10/13/95	ADDENDUM 1
DATE	REVISION
STATE OF HAWAII DEPARTMENT OF TRANSPORTATION HIGHWAYS DIVISION ROOF WALKWAYS COMMON WORK H-3 FINISH (UNIT III) FAIP NO. I-H3-1(75), UNIT III T.K. TUNNEL/ACCESS ROADS SCALE: 1" = 20' DATE: JUN 1995	
SHEET NO. 7A1	OF 5 SHEETS

STATE OF HAWAII
DEPARTMENT OF TRANSPORTATION
HIGHWAYS DIVISION
**ACCESS OPENING SAFETY
RAILING — HALAWA**
COMMON WORK
H-3 FINISH (UNIT III)
FAIP NO. I-H3-I(75), UNIT III
T.K. TUNNEL/ACCESS ROADS
SCALE: NONE
DATE: JUN 1995
SHEET NO. 7SI OF 6 SHEETS

POTABLE WATER TANK

SCALE: 1/2" = 1'-0"

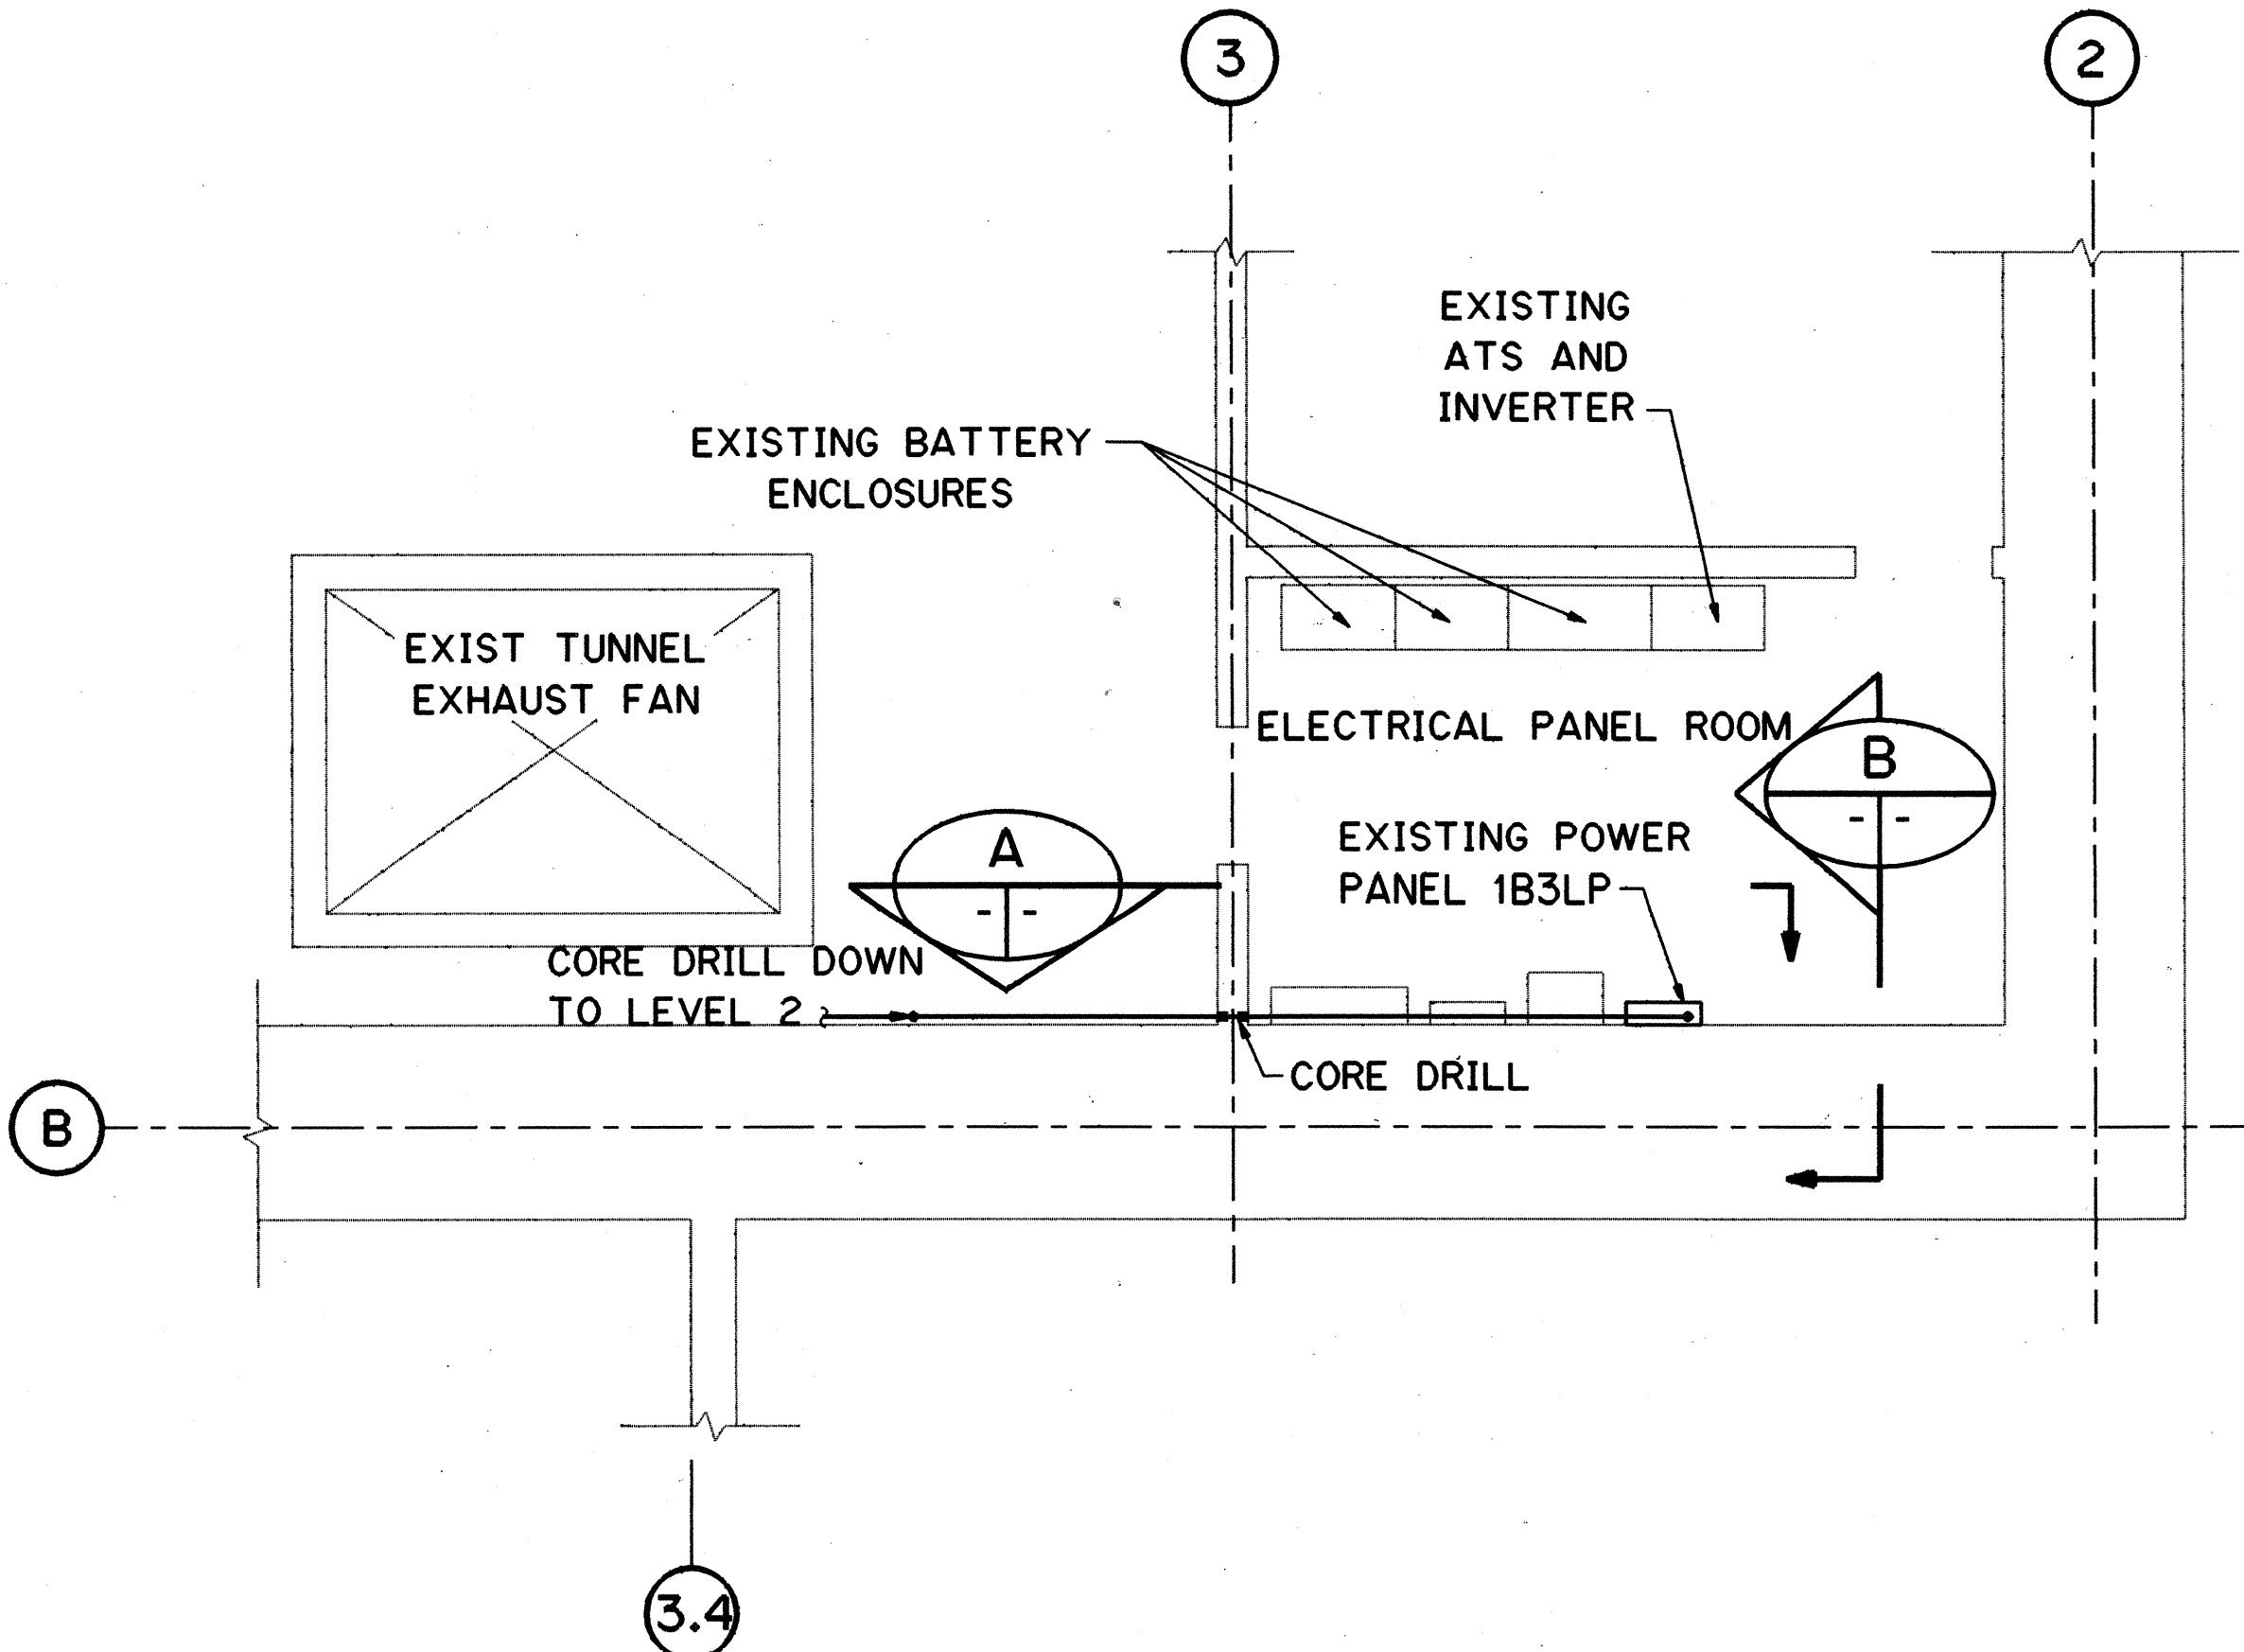
DATE	REVISION
10/27/95	ADDENDUM 2- DELETED POTABLE WATER STOR. TK ITC, ADDED MONITORING CONDUIT
STATE OF HAWAII DEPARTMENT OF TRANSPORTATION HIGHWAYS DIVISION	
HALAWA POTABLE WATER TREATMENT POWER PLAN	
COMMON WORK	
H-3 FINISH (UNIT III)	
FAIP NO. I-H3-1(75), UNIT III	
T.K. TUNNEL/ACCESS ROADS	
SCALE: 1/2" = 1'-0"	DATE: JUN 1995
SHEET NO. 7E1	OF 6 SHEETS

WATER TREATMENT AND TANK
ACCESS ROOM PLAN
HAIKU OB PORTAL BLDG-LEVEL 2

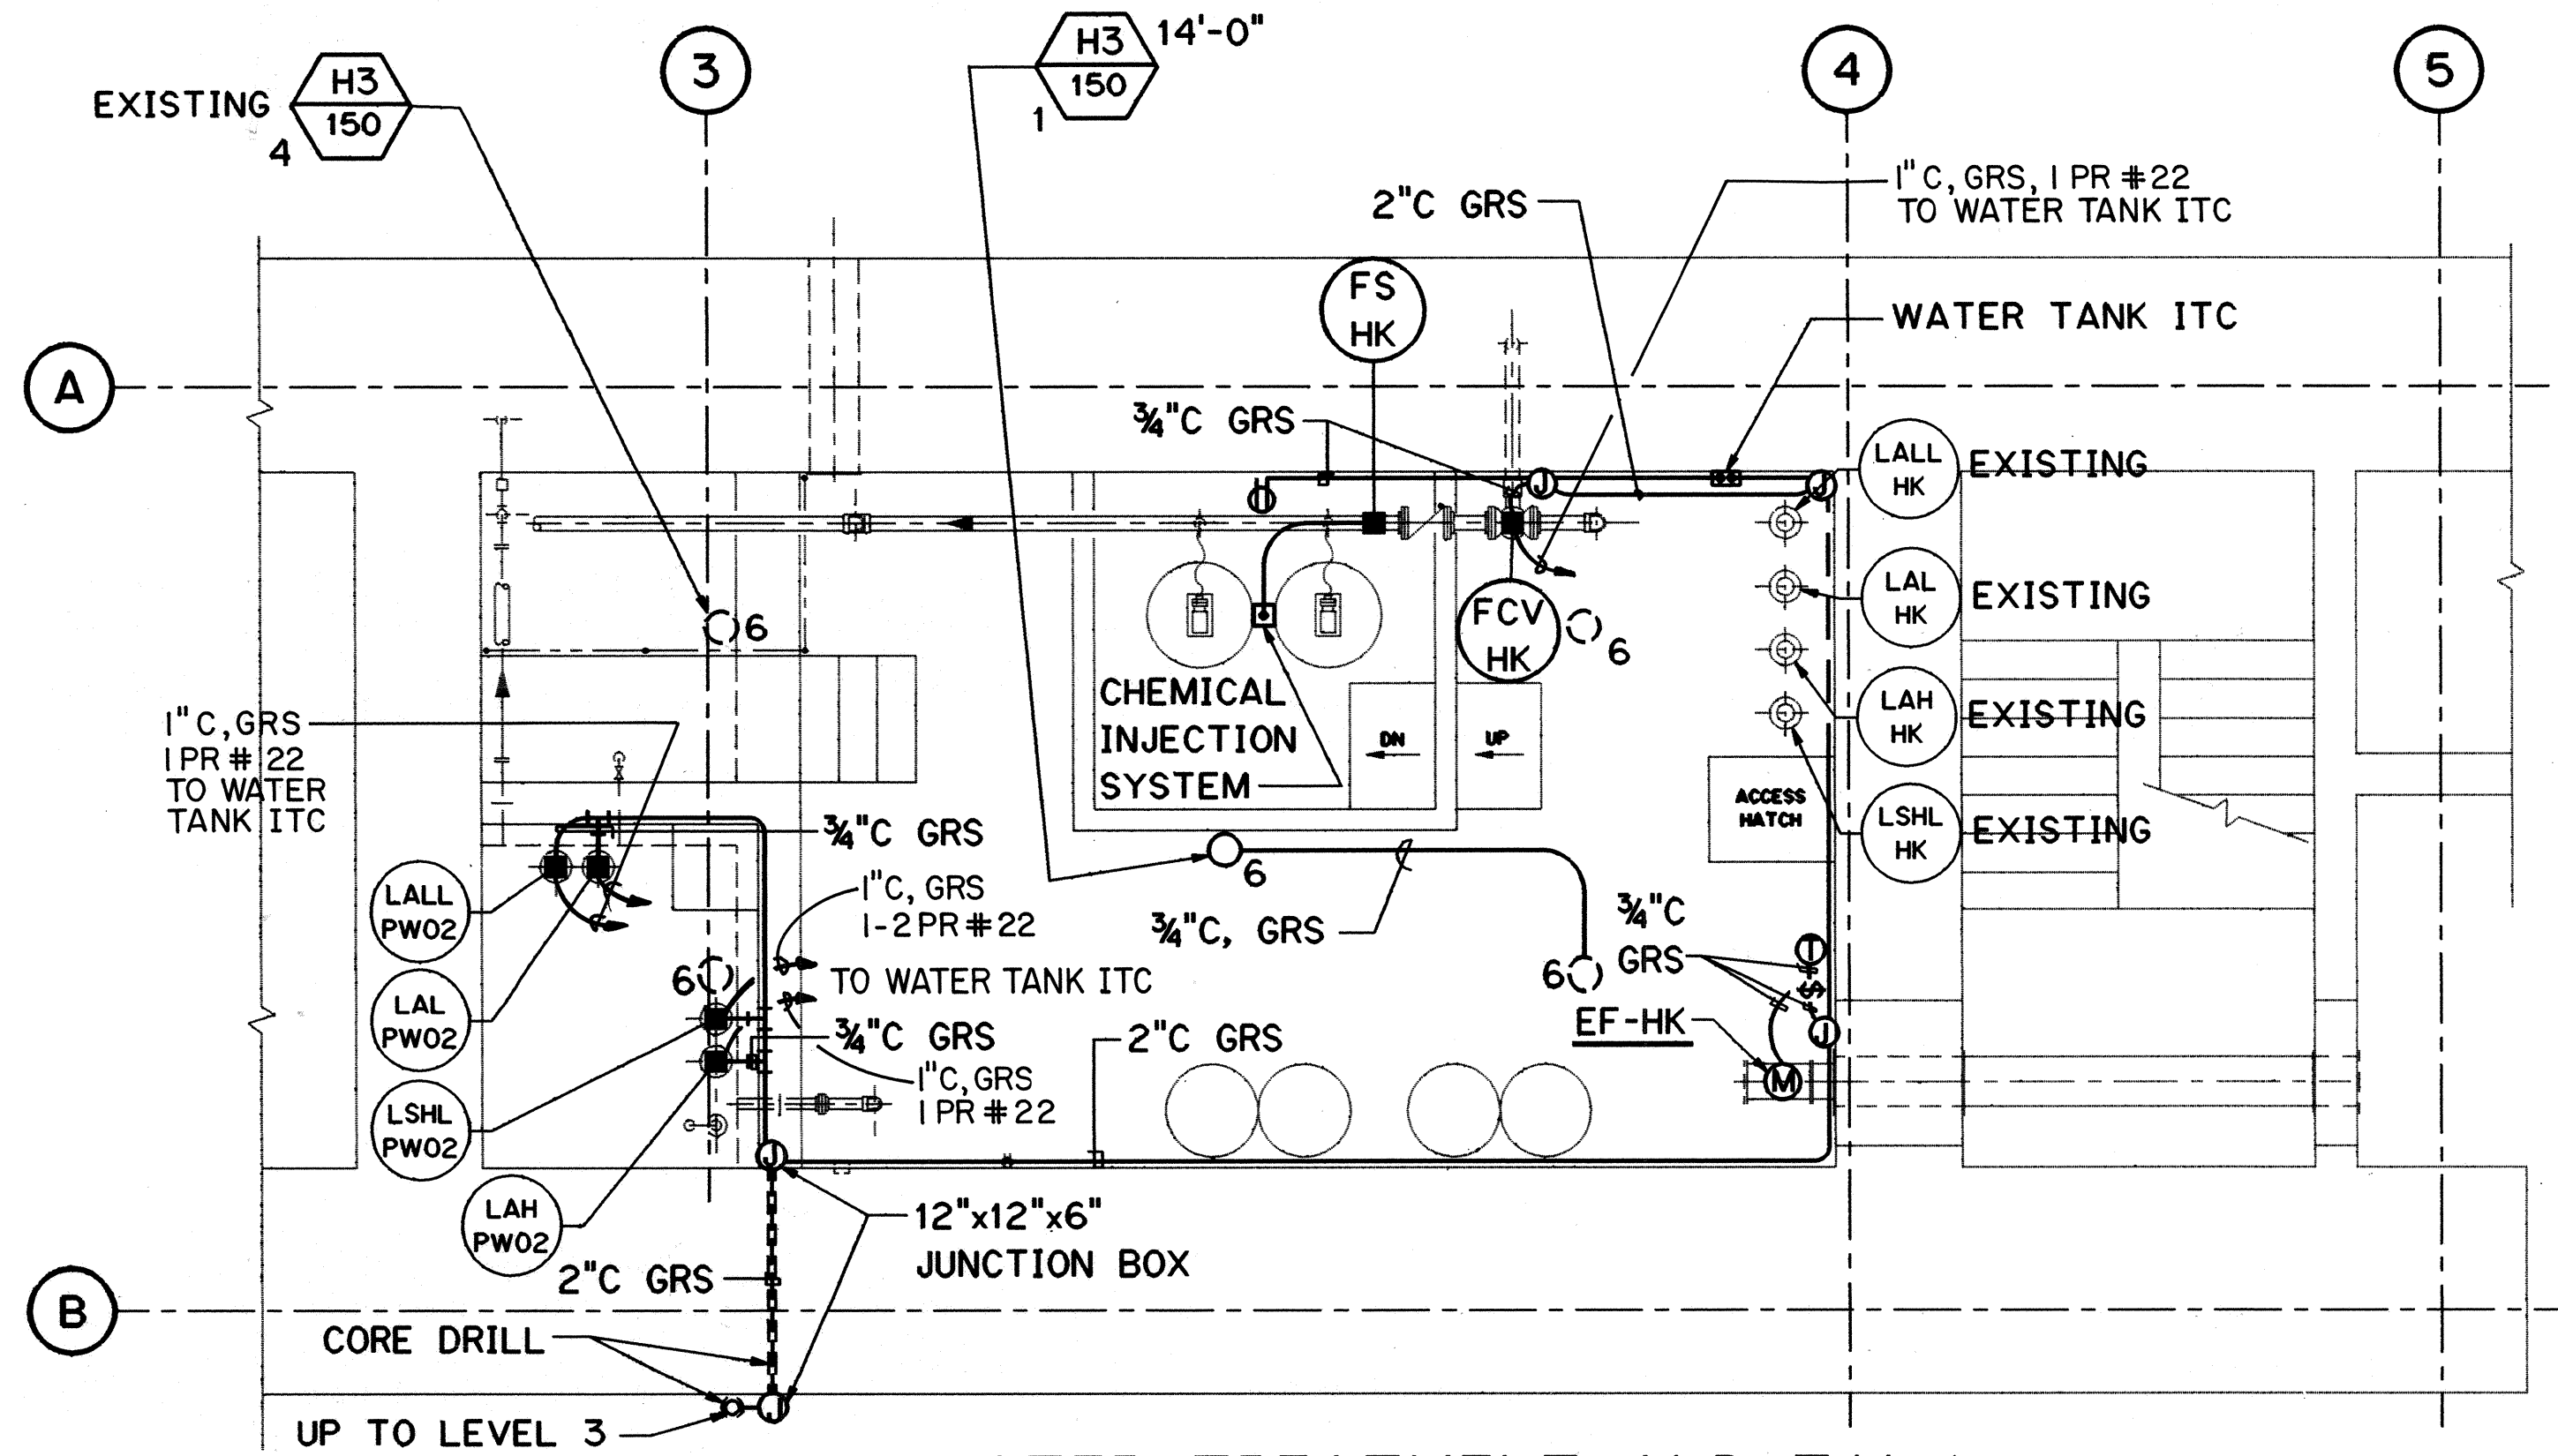
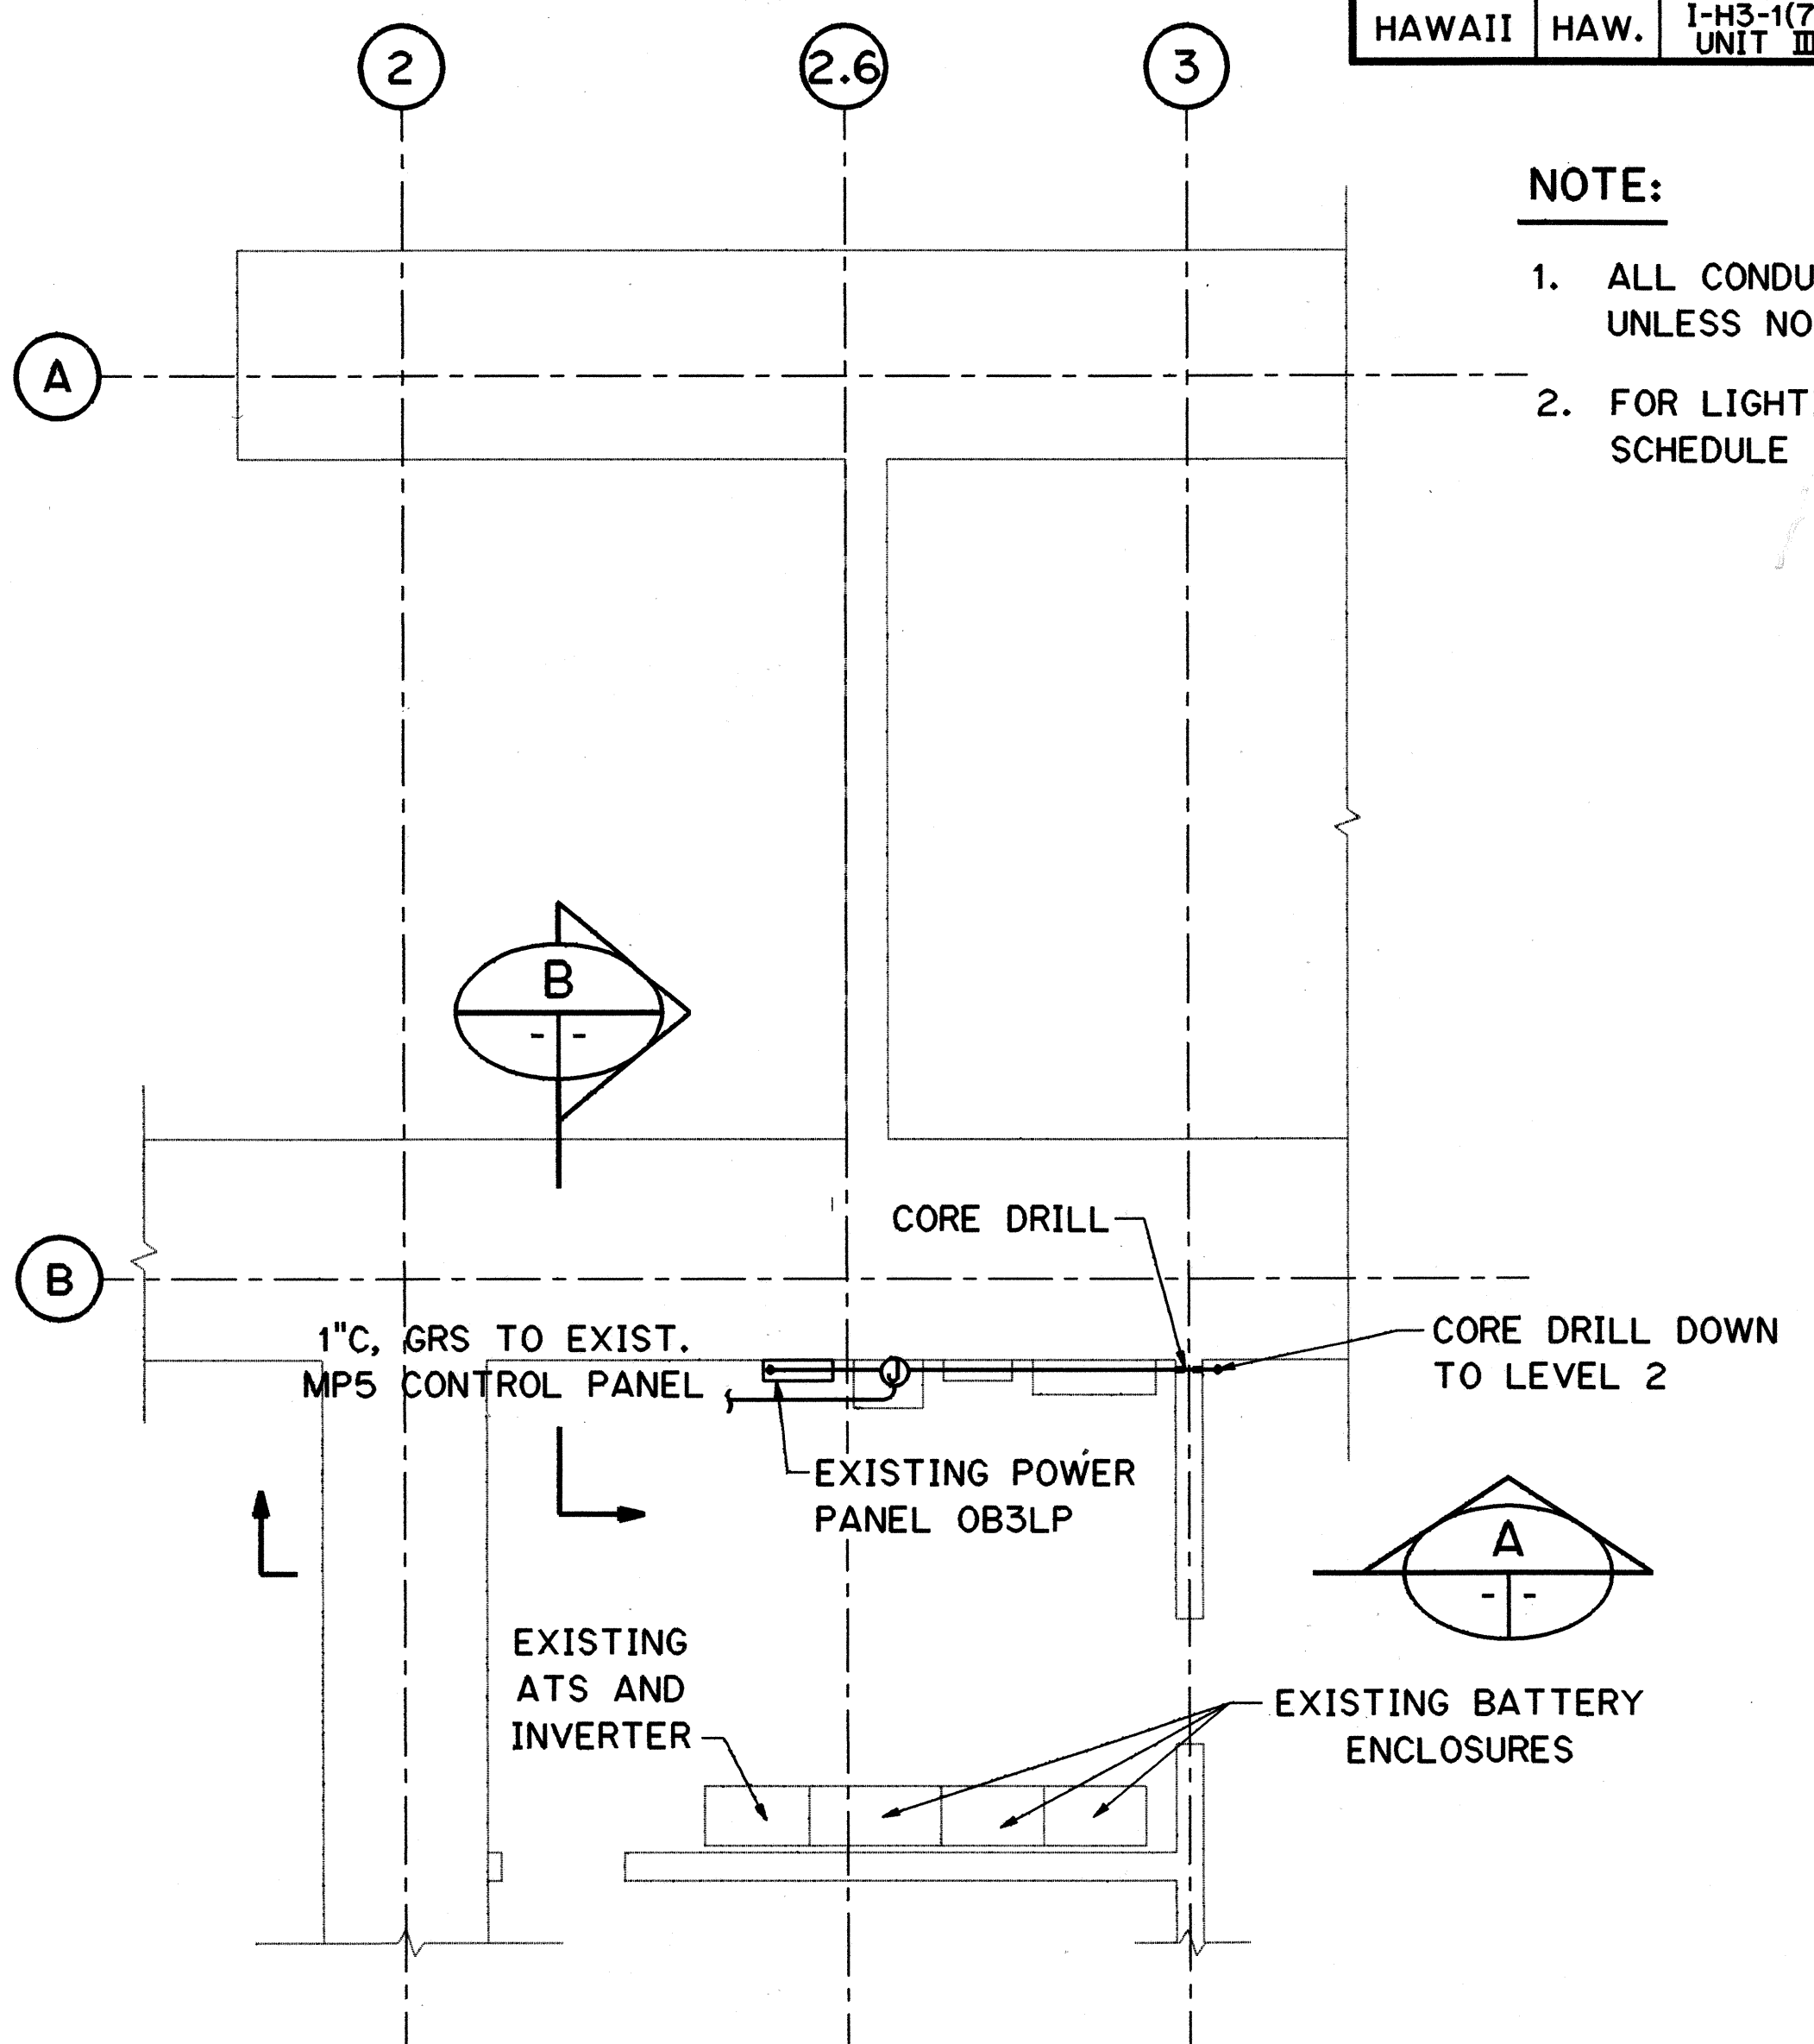
10/27/95	ADDENDUM 2-ADDED MONITORING CONDUIT
DATE	REVISION
STATE OF HAWAII DEPARTMENT OF TRANSPORTATION HIGHWAYS DIVISION	
HAIKU WATER TREATMENT	
POWER PLAN	
COMMON WORK	
H-3 FINISH (UNIT III)	
FAIP NO. I-H3-1(75), UNIT III	
T.K. TUNNEL/ACCESS ROADS	
SCALE: AS SHOWN	DATE: JUN 1995
SHEET NO. 7E2	OF 6 SHEETS
